SUBJECT: BORON CONCENTRATION IN BORIC ACID TANKS REDUCED, SALEM NUCLEAR
GENERATING STATION, UNIT NO. 2 (TAC NO. M86724)

Amendment No. 133
License No. DPR-75

ATTACHMENT TO LICENSE AMENDMENT NO. 133

SAFETY EVALUATION BY THE OFFICE OF NUCLEAR REACTOR REGULATION

Figure 3.1-2

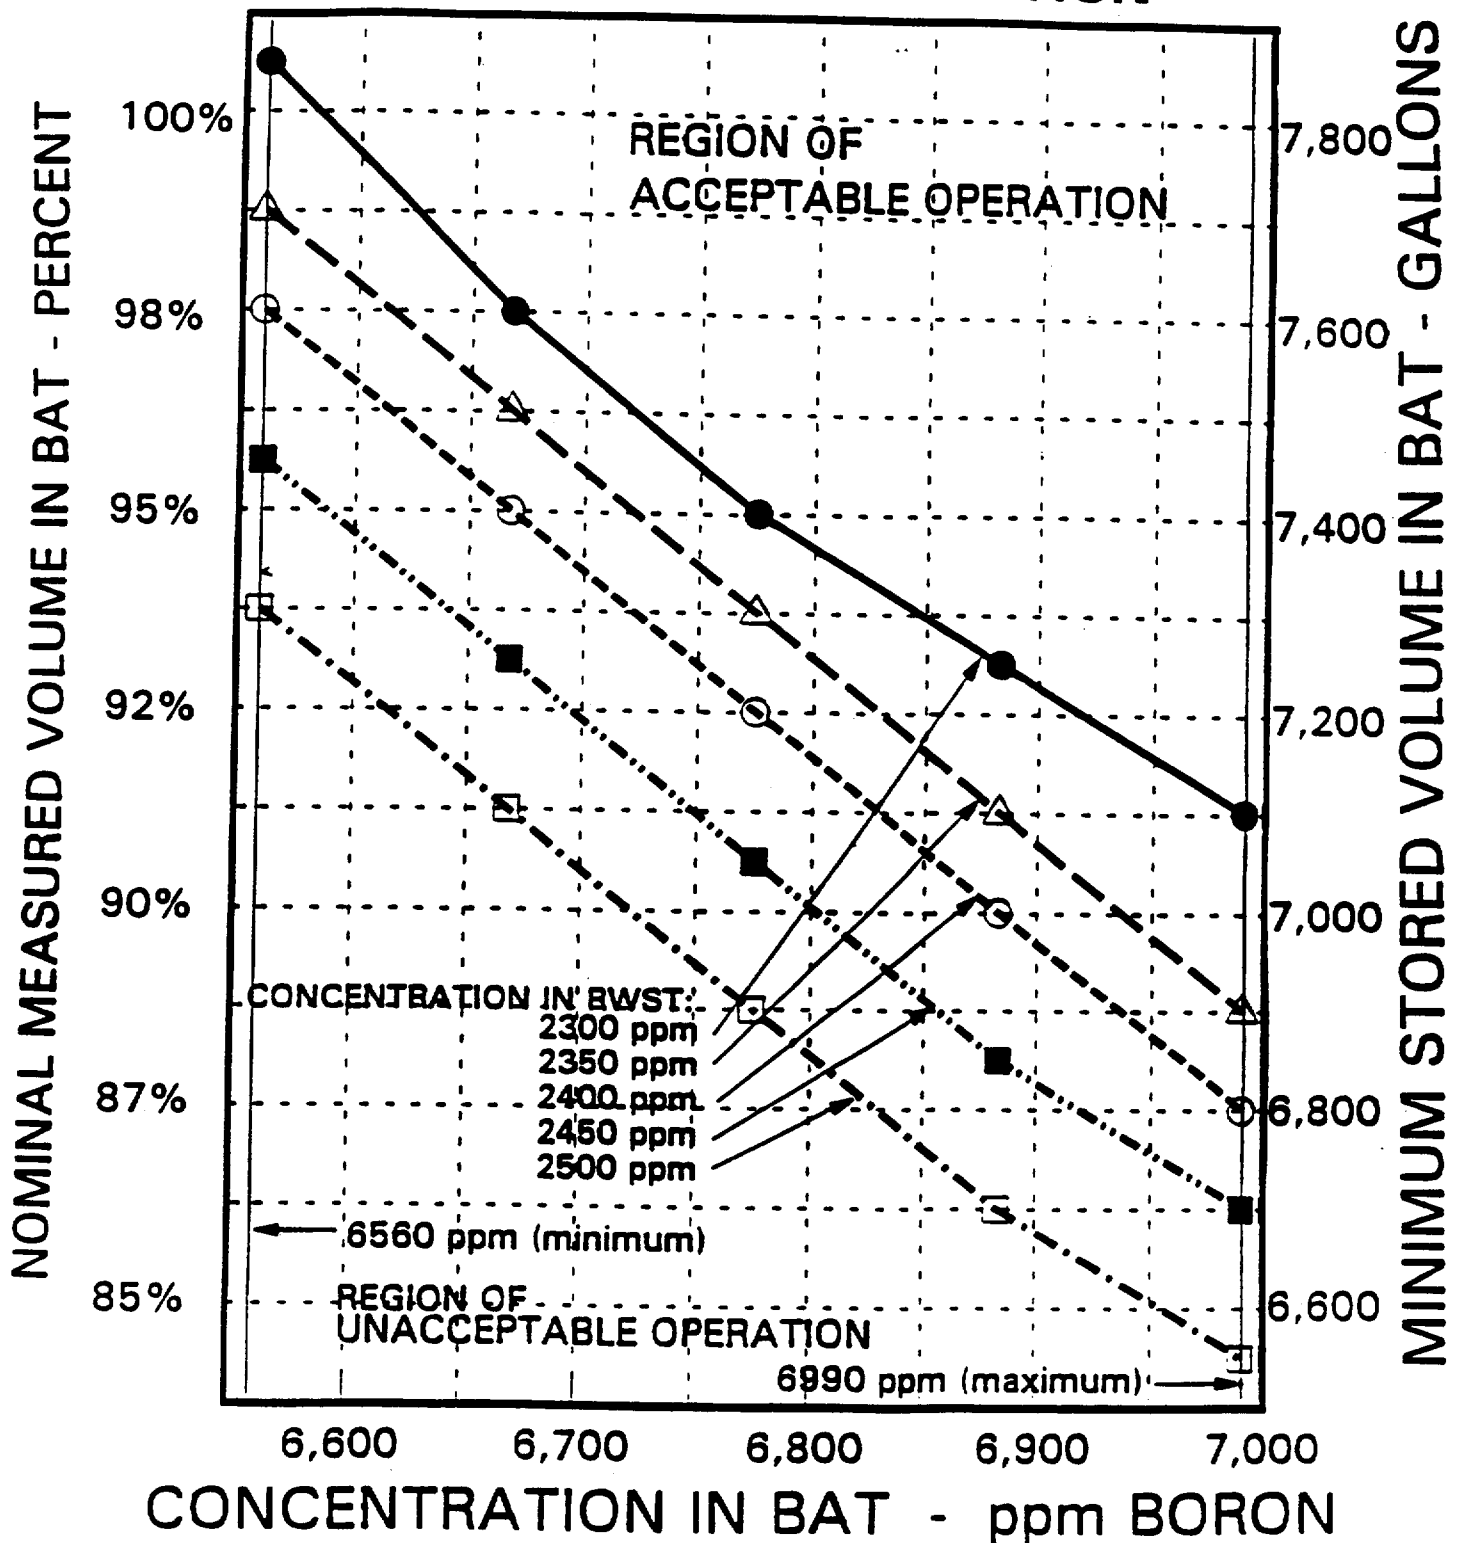
- a. A boric acid storage system with:
 1. A contained volume of borated water in accordance with figure 3.1-2,
 2. A Boron concentration in accordance with Figure 3.1-2, and
 3. A minimum solution temperature of 63°F.
- b. The refueling water storage tank with:
 1. A contained volume of between 364,500 and 400,000 gallons of water,
 2. A boron concentration of between 2,300 and 2,500 ppm, and
 3. A minimum solution temperature of 35°F.
